RESPONSE TO REVIEW

271 Main Street
Lynnfield, Massachusetts

RE: 271 Main Street / Hickman

The following is in response to the letter from Linden Engineering Partners dated January 26, 2021 which reviewed the Definitive Subdivision at 271 Main Street in Lynnfield, Massachusetts.

WATERSHED MAP

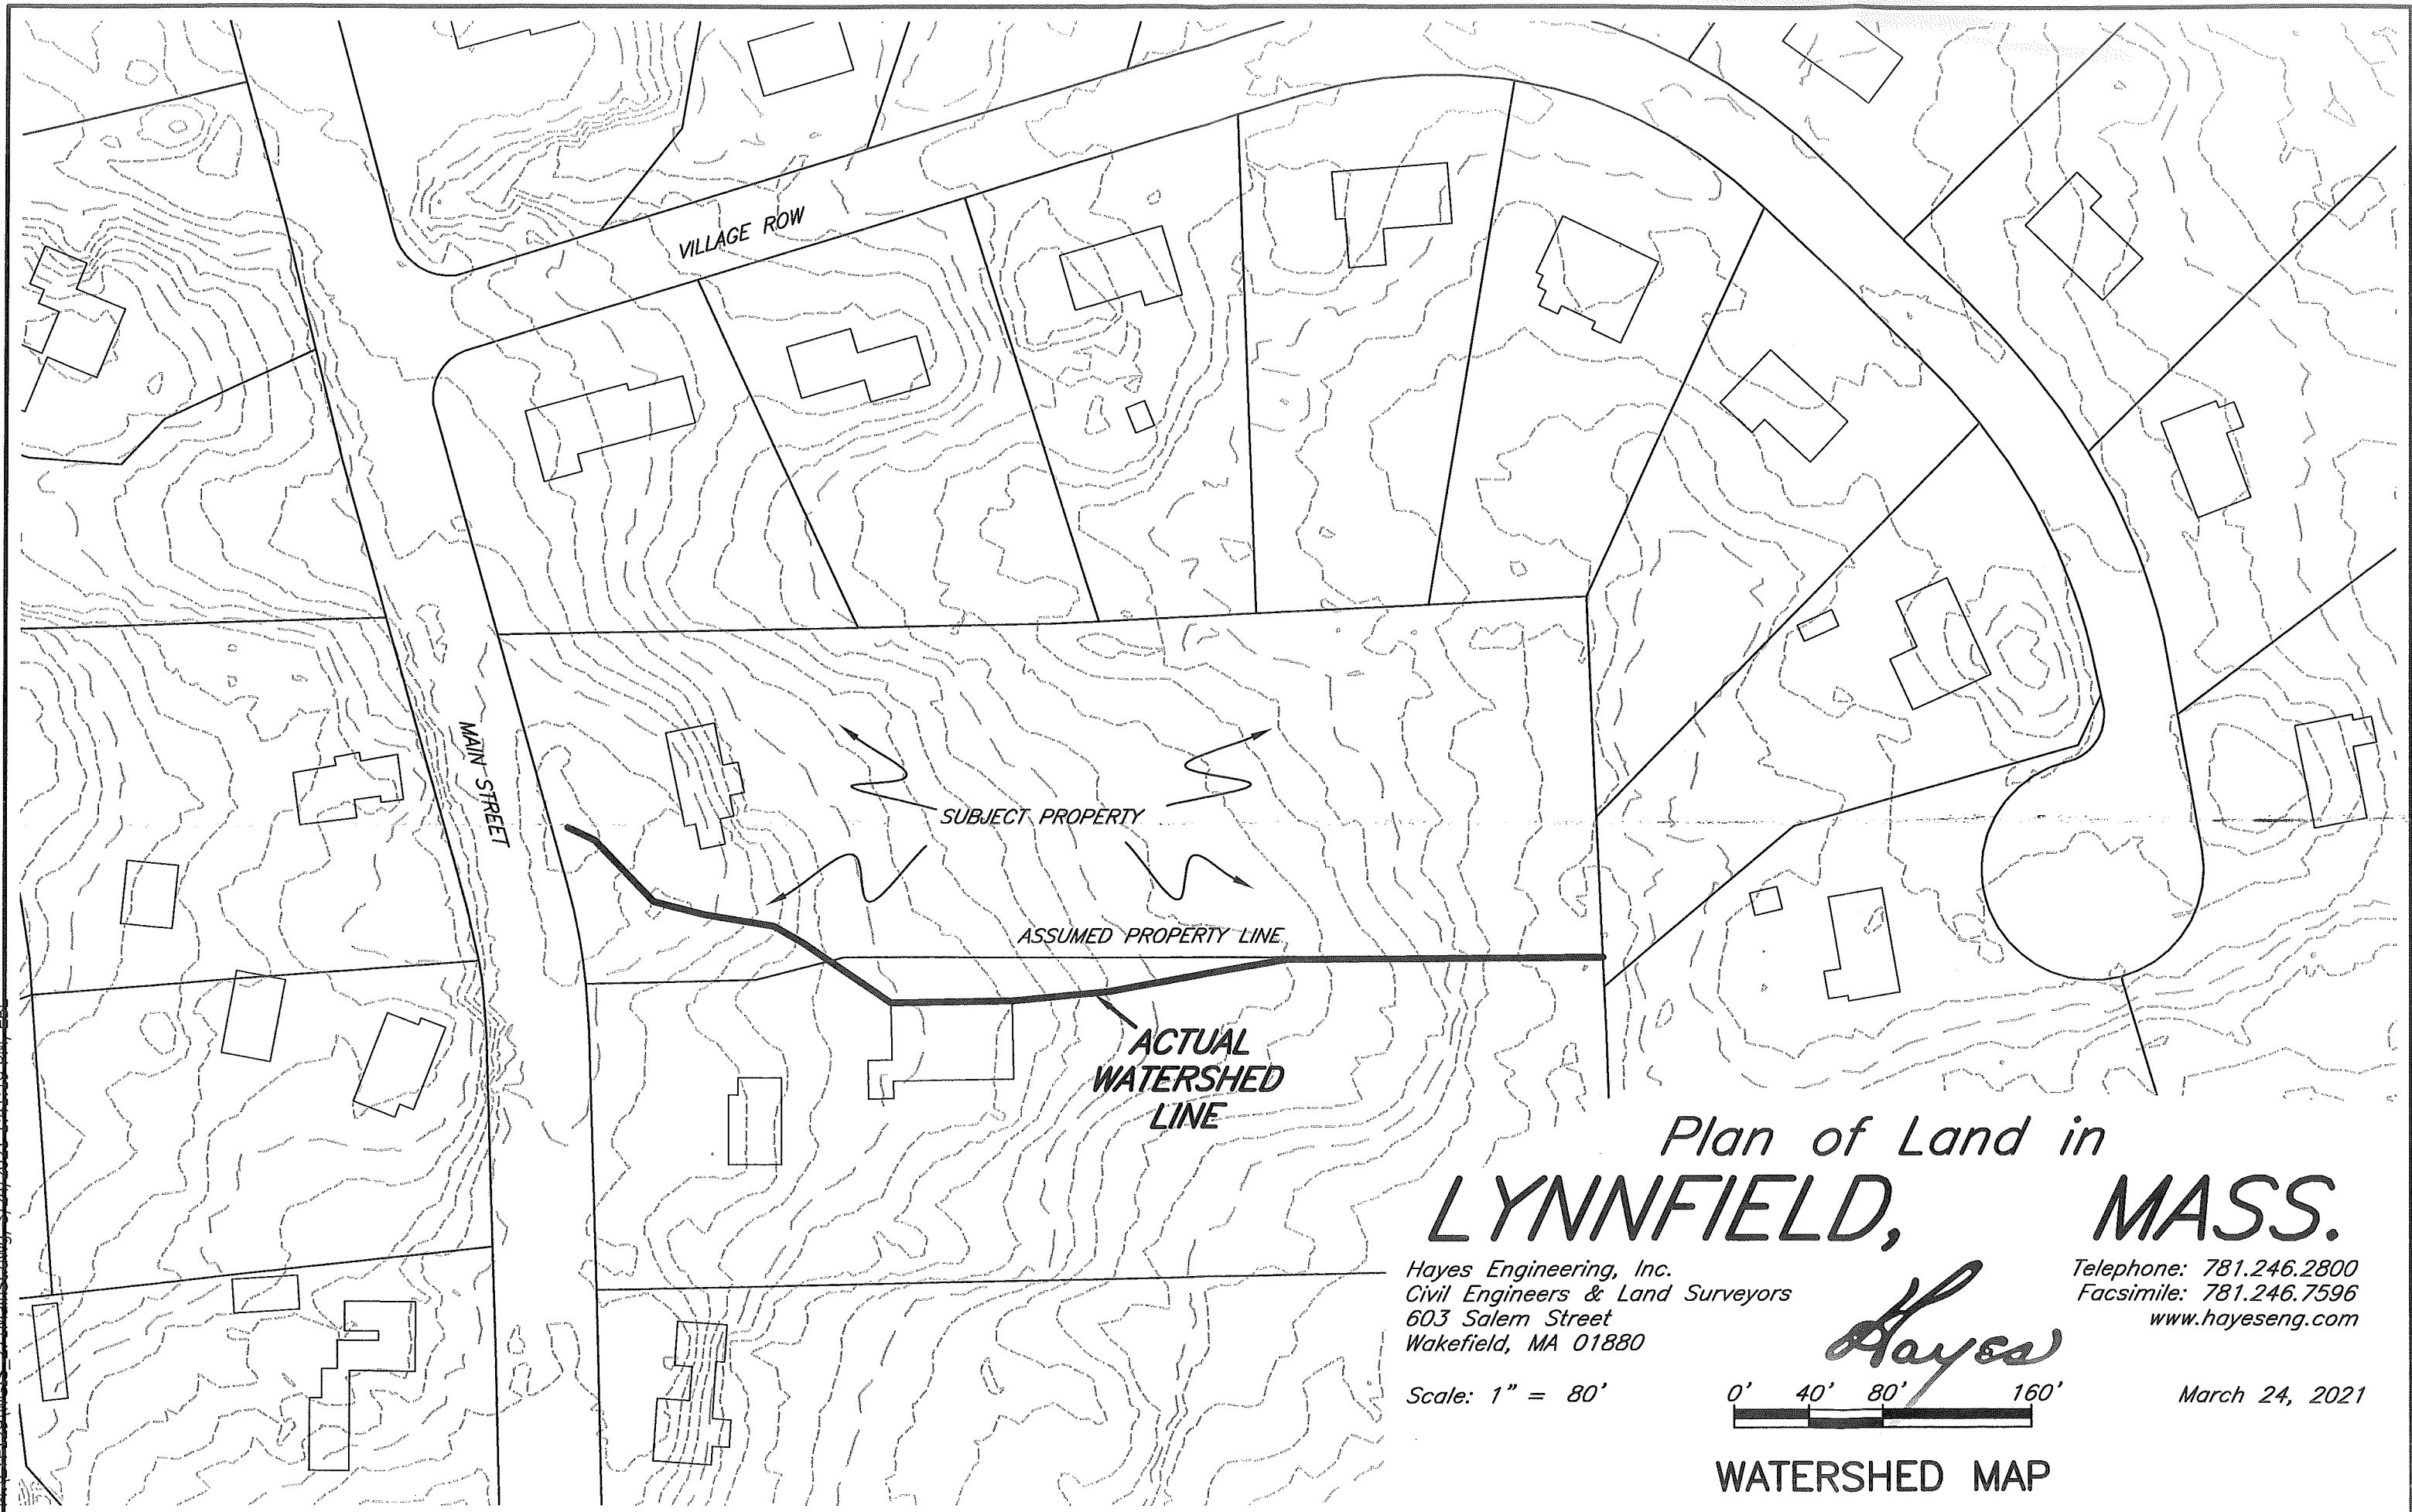
43. *The configuration of the watershed boundary between EX-1 and EX-2 does not seem to follow the path the runoff will take to get to the discharge point. The Engineer needs to re-evaluate this and revise or explain his reasoning as to why this boundary is configured this way. It would also be preferred if the watersheds considered water flow from the abutting property to two common points in the wetland and intermittent stream on the edge of the site.*

3. It’s unclear the path of water being shed from catchment area EX1. It appears to just end at the property line. This needs to be looked at in relation to the proposed runoff to determine if adjacent land will be affected from the flow of water. **We believe this has been complied with, a LIDAR topography map is included. Changing the watershed line would not change the areas.**

Ex-1 and Ex-2 are coincident with land use i.e. house lot developed vs. open field flow from abutting property would not change with revised water shed. (See attached).
